**NO: 24-02-99**

**SUBJECT: A/C Compressor Service**

**DATE: Jan. 29, 1999**

Figure 1

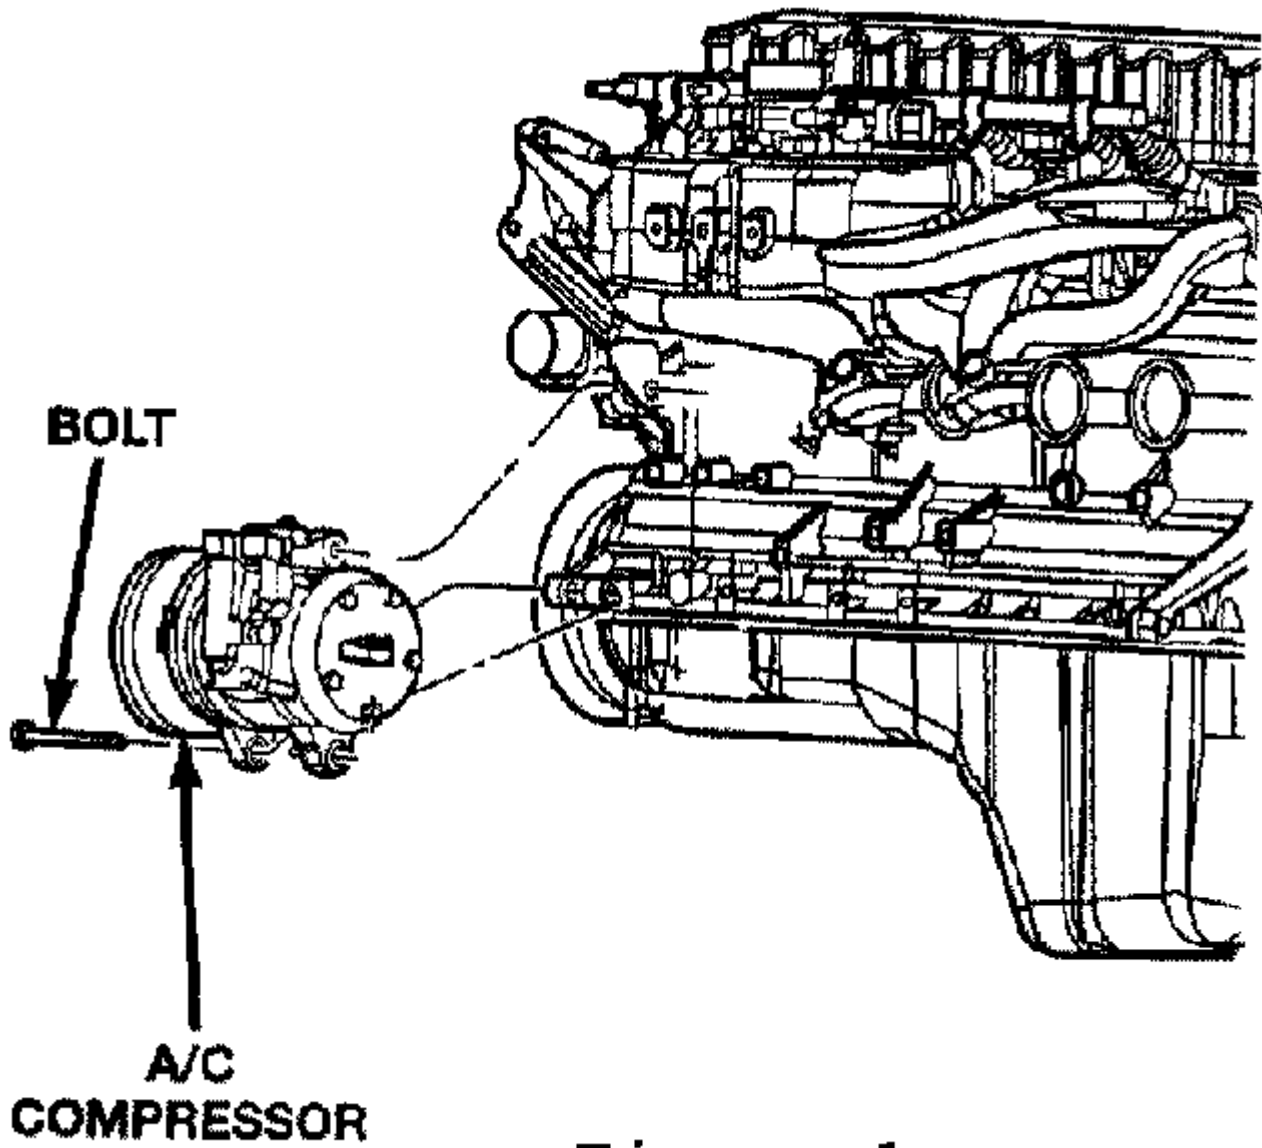
When service requiring the removal of the A/C compressor is performed, care must be used when installing the lower compressor mounting bolt ([See Figure 1](#)). The torque specification on this bolt is 54 Nm (40 ft. Lbs.). Excessive tightening of the bolt can damage the engine block. **Do not use impact tools in this area.**

A new bolt has been released which has a break away feature incorporated to protect the engine block. This bolt, p/n 53013390AA, should be installed any time the A/C compressor is serviced.
